SEWAGE DISPOSAL SYSTEM

HOWARD COUNTY HEALTH DEPARTMENT

SUBDIVISION Hyde Property LOT 15 ROAD 12291 Scaggsville Road

PLOT PLAN

LOCATION DRAWING

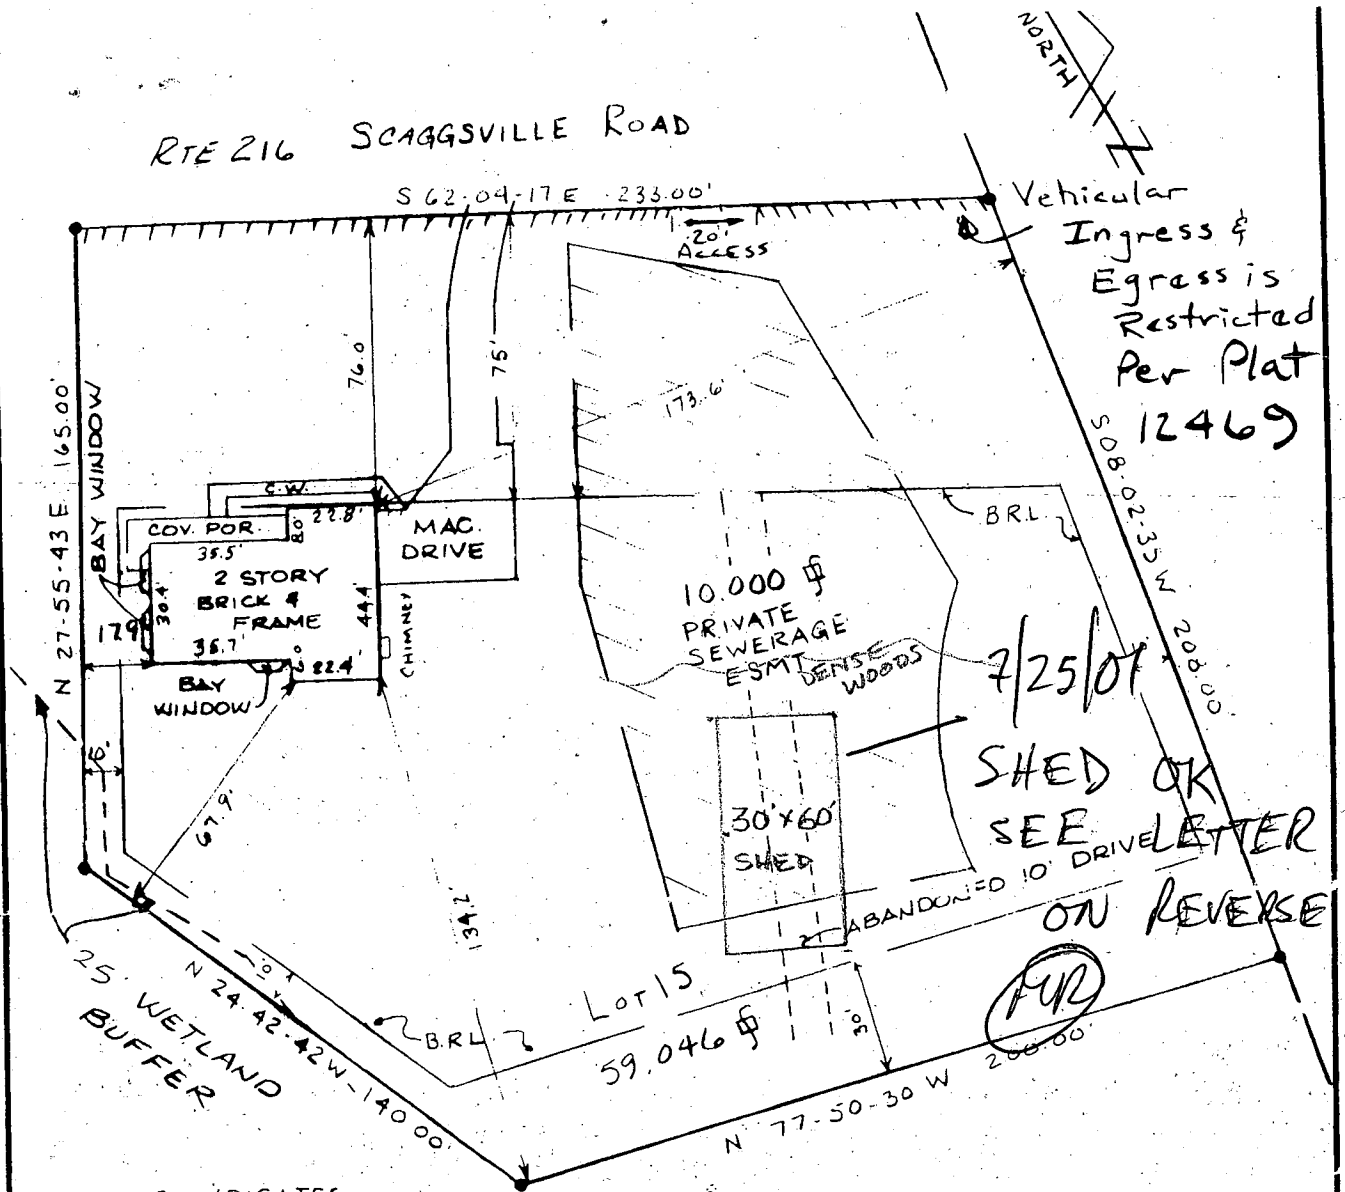
7/8/99
Shown deck location will have no impact to ex. well or septic

Note: Driveway access is in violation of Plat restriction.
